Change Order

PROJECT: *(Name and address)*
Mansfield ISD 2024 Bond Program - A2
Summit High School
Baseball/Softball/Turf & Batting Cages
1071 Turner Warnell Road
Arlington, Texas 7601

Prime Contract Change Order #09: CE #009 - RFP#04 - Batting Cage & Bullpen Relocation

RFP #4

C3.00

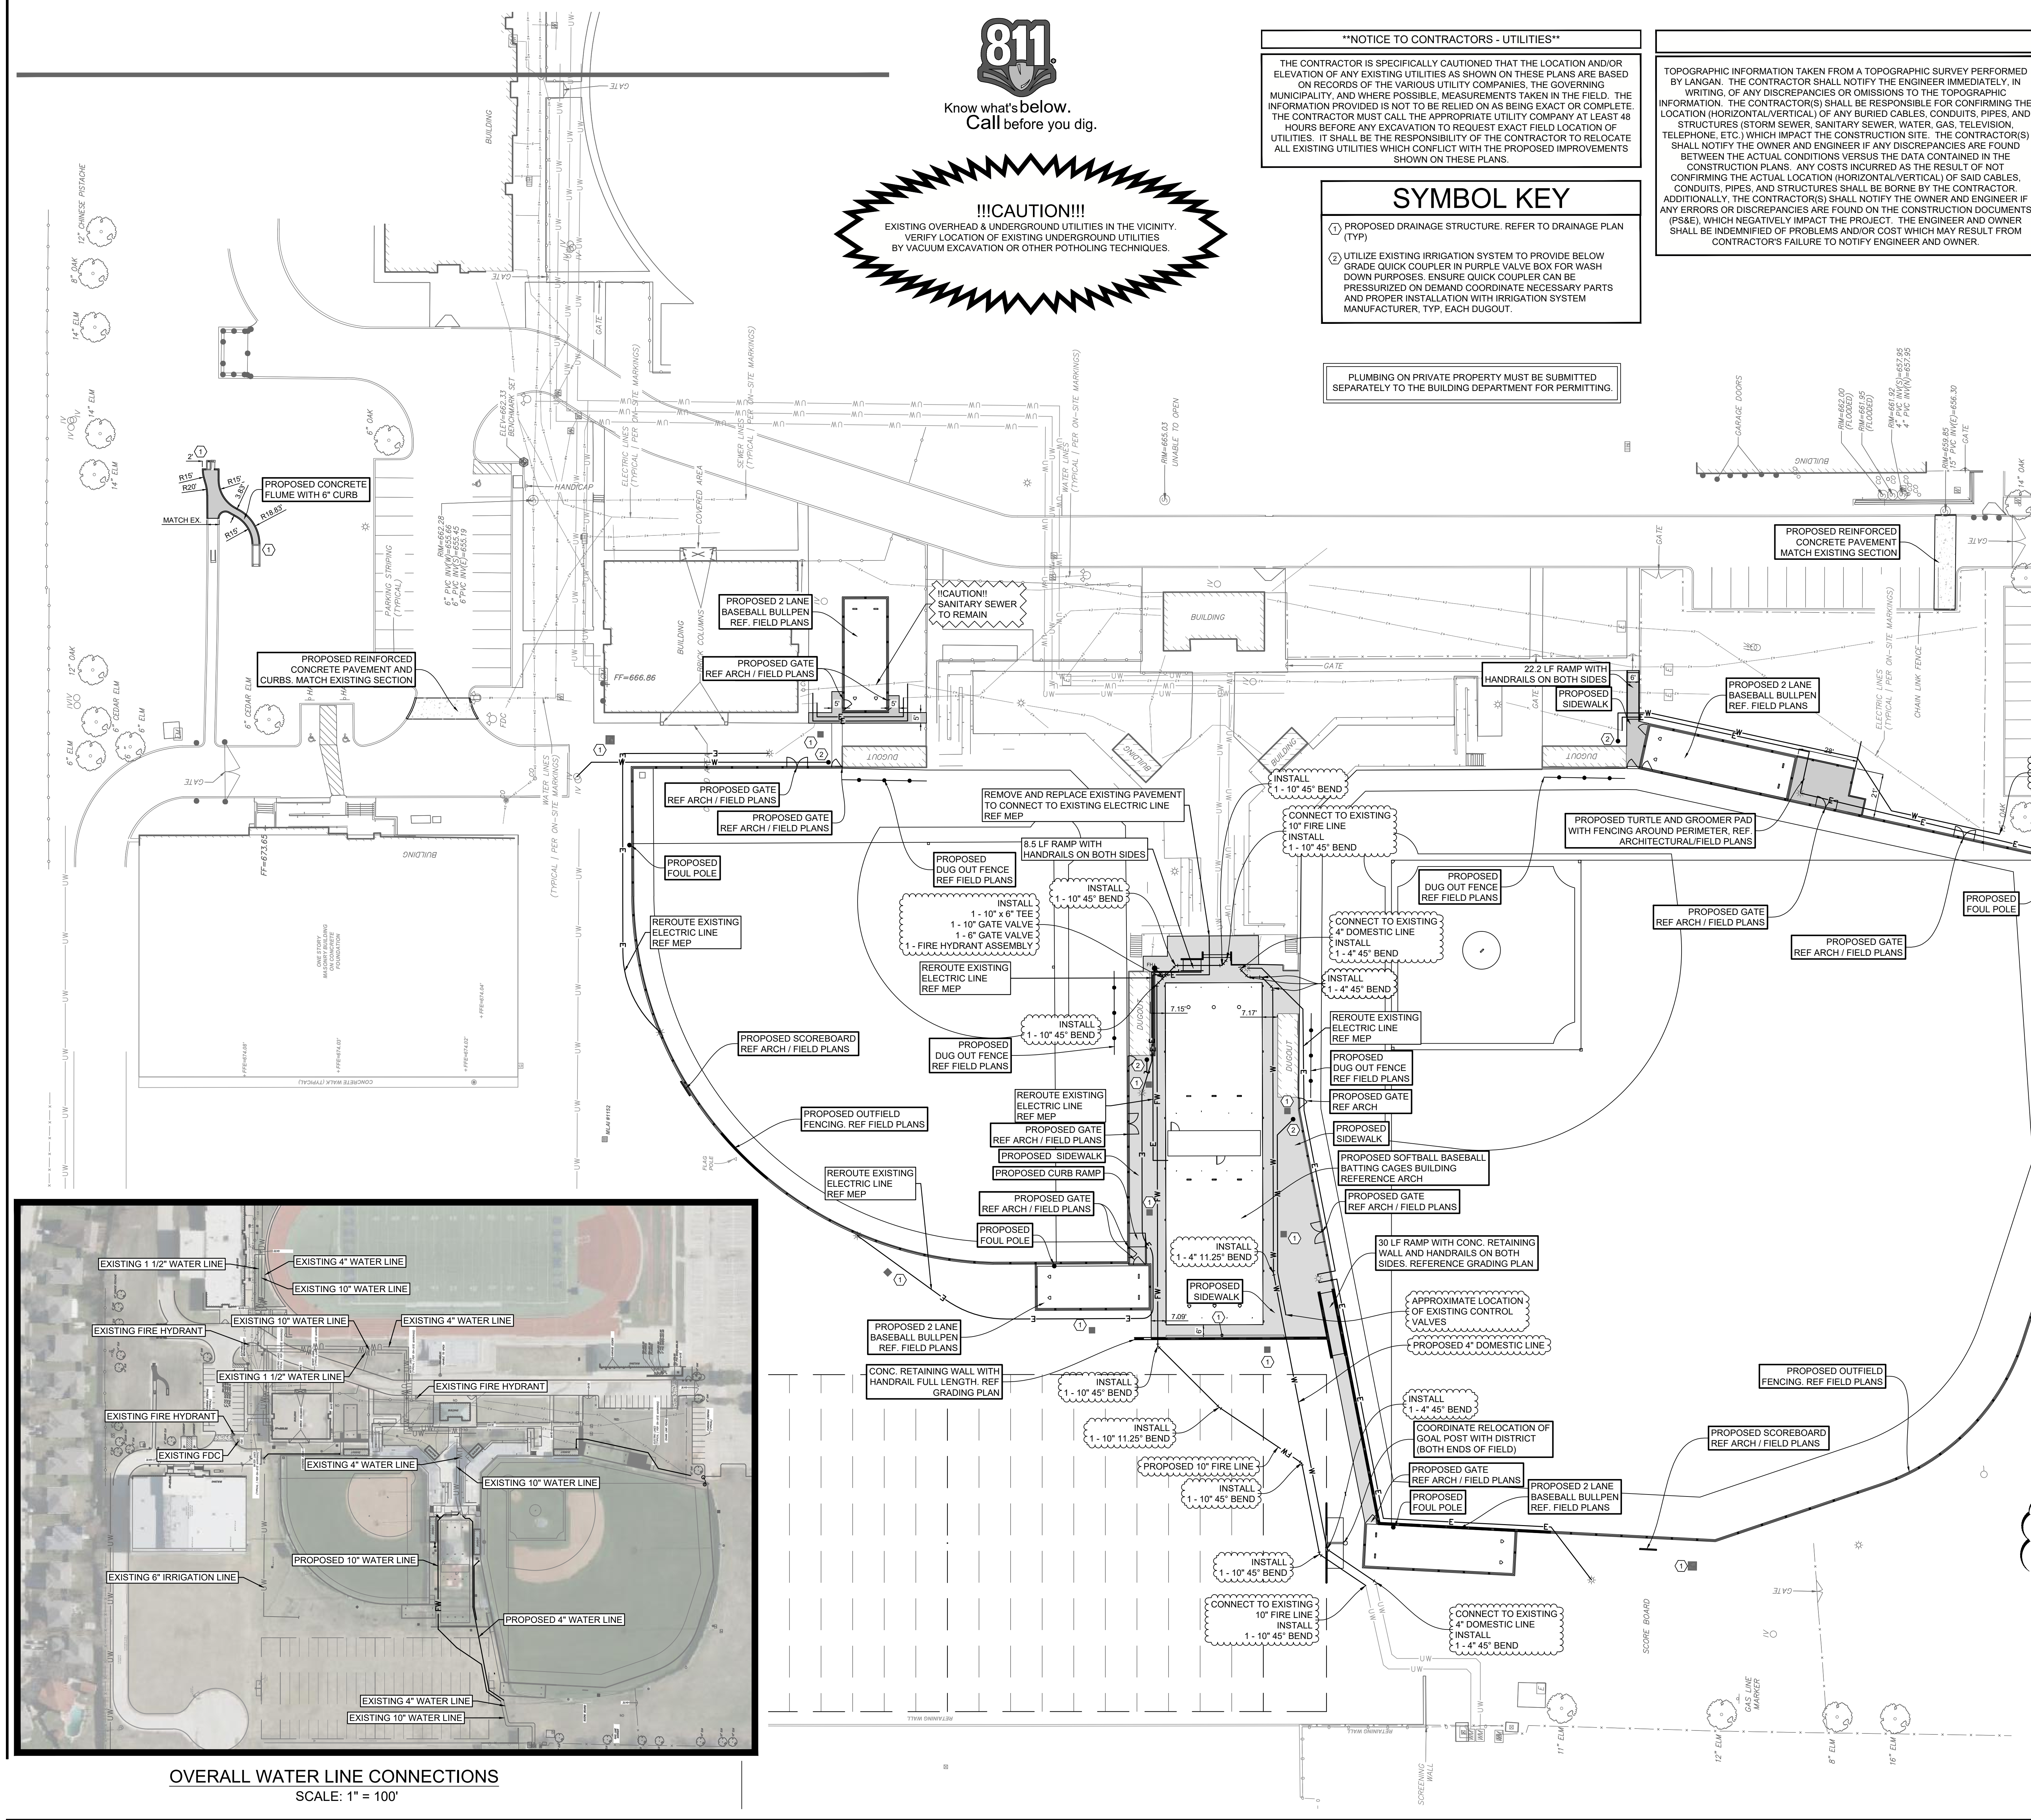
- 1) DISPLAYED RE-ROUTED ELECTRIC LINES AROUND OUTFIELD OF SOFTBALL FIELD
- 1) ADDED PROPOSED FIRE HYDRANT EAST OF PROPOSED BATTING CAGES
- 2) ADDED VIEW PORT TO SHOW THE OVERALL WATER LINE CONNECTIONS
- 1) REVISED LOCATION OF PROPOSED BATTING CAGES BUILDING
- 2) ADDED RETAINING WALLS AT BASEBALL OUTFIELD PERIMETER AND WEST OF BUILDING
- 3) REVISED BASEBALL BULLPEN LOCATION
- 4) REVERSED PAVEMENT EAST & SOUTHWEST OF BUILDING
- 5) REVISED FIRE HYDRANT LOCATION NORTH OF BUILDING
- 6) REVISED 10" & 4" WATER LINES ALIGNMENTS

- 1) DISPLAYED RE-ROUTED ELECTRIC LINES AROUND OUTFIELD OF SOFTBALL FIELD
- 1) ADDED PROPOSED FIRE HYDRANT EAST OF PROPOSED BATTING CAGES
- 2) ADDED VIEW PORT TO SHOW THE OVERALL WATER LINE CONNECTIONS
- 1) REVISED LOCATION OF PROPOSED BATTING CAGES BUILDING
- 2) ADDED RETAINING WALLS AT BASEBALL OUTFIELD PERIMETER AND WEST OF BUILDING
- 3) REVISED BASEBALL BULLPEN LOCATION
- 4) REVISED PAVEMENT EAST & SOUTHWEST OF BUILDING
- 5) REVISED FIRE HYDRANT LOCATION NORTH OF BUILDING
- 6) REVISED 10" & 4" WATER LINES ALIGNMENTS
